BOARD OF ADJUSTMENT APPLICATION

PROPERTY ADDRESS 73 Franklin St.

RE: Zoning Letter of Denial
Above Ground Pool

**RE: Engineering Review
Above Ground Pool**

BOARD OF ADJUSTMENT APPLICATION SITE PLAN

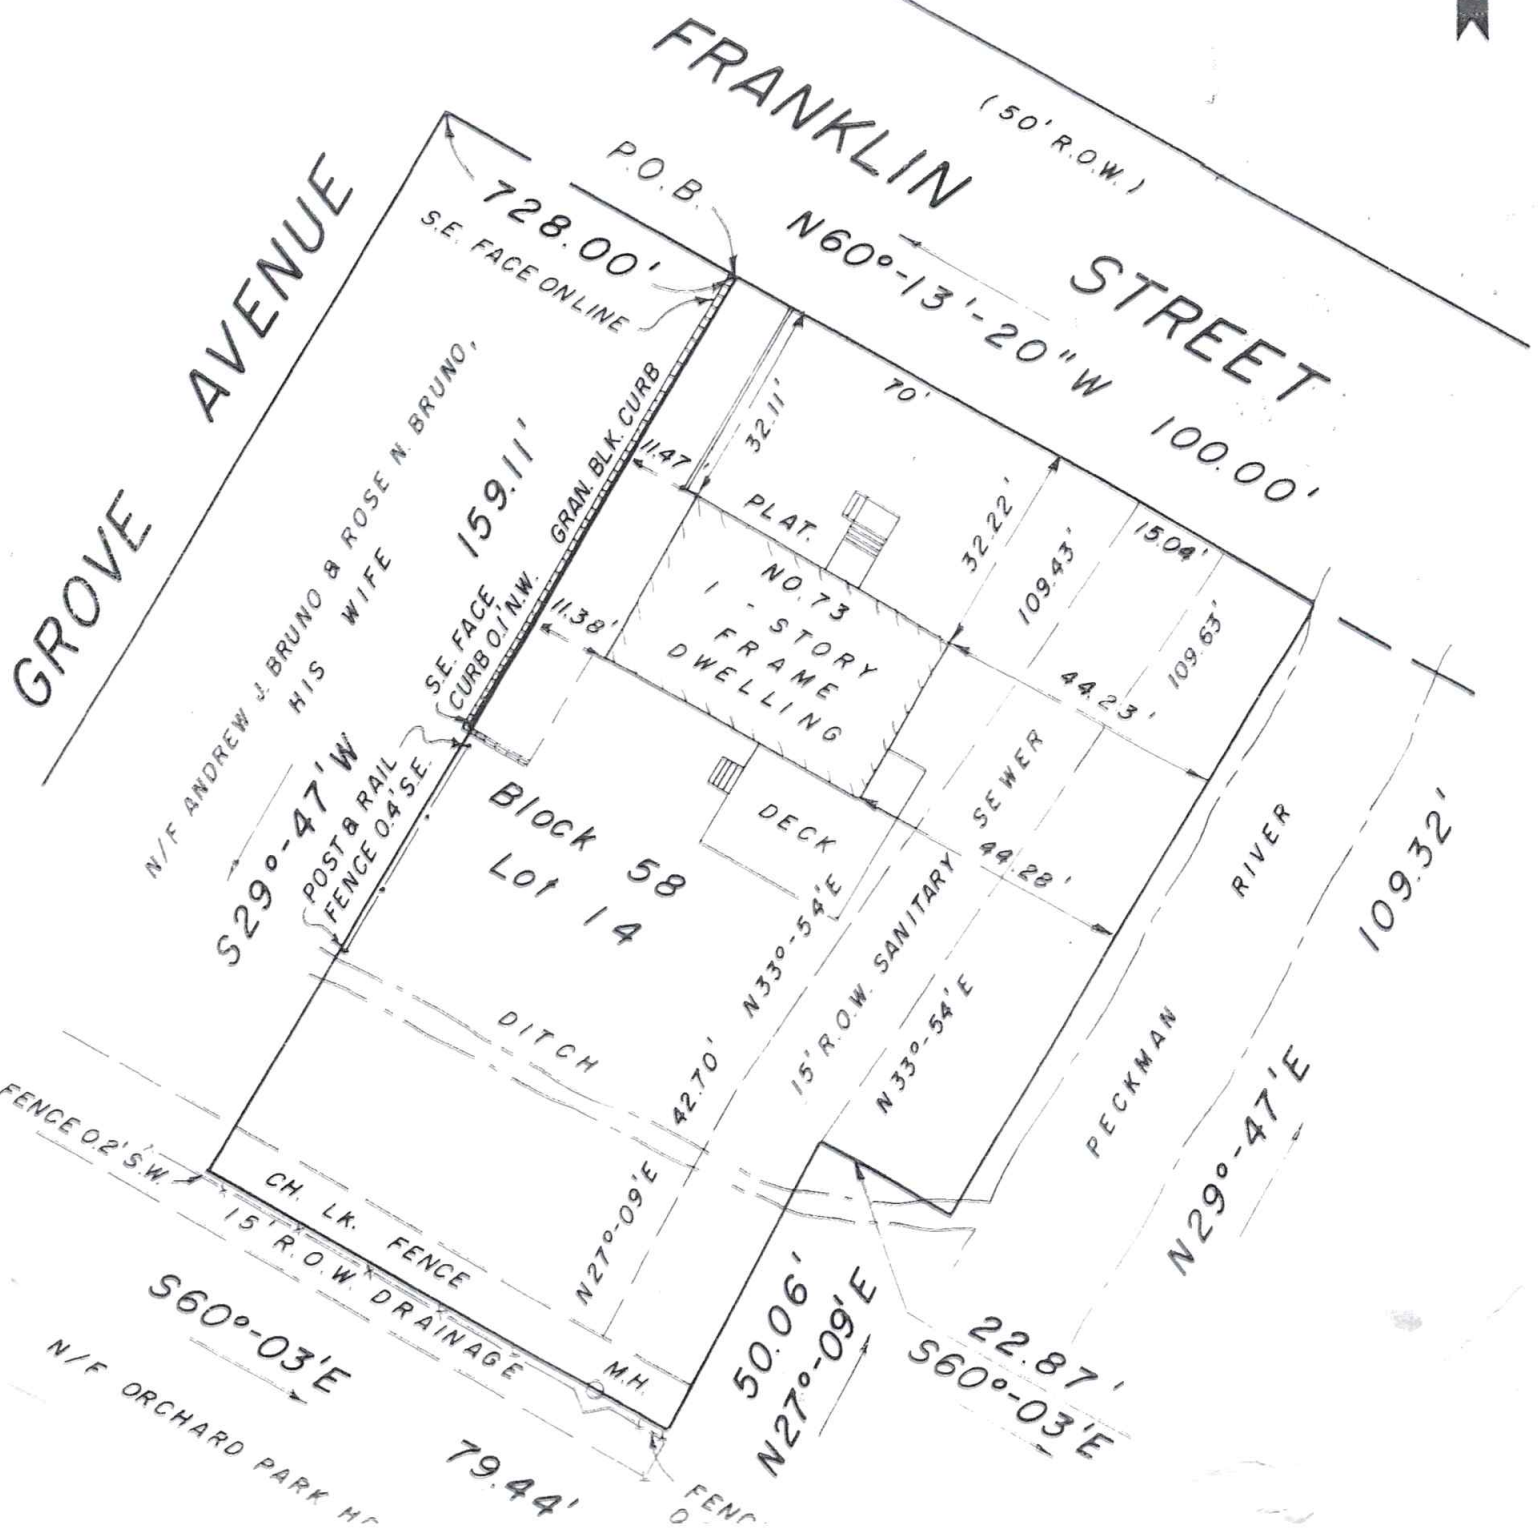
- A. Required Swimming Pool Setback to a Side Yard 10 (Feet) 8 Feet Proposed; **VARIANCE**
Required Swimming Pool Setback to a Rear Yard 10 (Feet) 54± Feet Proposed; **COMPLIES**
Required Swimming Pool Setback to a Principal Bldg. 10 (Feet) 19± Feet Proposed; **COMPLIES**
- B. All Filtration Equipment shall be located not less than 5 feet from a property line. > 5 Feet; **COMPLIES**

1. The proposed swimming pool does not meet the minimum required side yard setback.
VARIANCE REQUIRED §150-7.5 A. 10 Foot Side Yard Required; 8 Foot Side Yard Proposed.

- The subject property is slightly impacted by the FEMA 100 yr. Flood Hazard Area. The survey shown on the plans indicates that no habitable space of the existing home nor the proposed addition are situated within that area and therefore no special FEMA or NJDEP Land Use Regulation Permits are required. A portion of the addition is within the 50 foot transition area as measured from the top of bank of the State regulated open waters of the Peckman River. Construction in this area is permissible under the State of NJ Dept. of Environmental Protection Flood Hazard Area Control Act Rules: "Permit by Rule" which grants permission to the local government officials to review and approve certain projects.
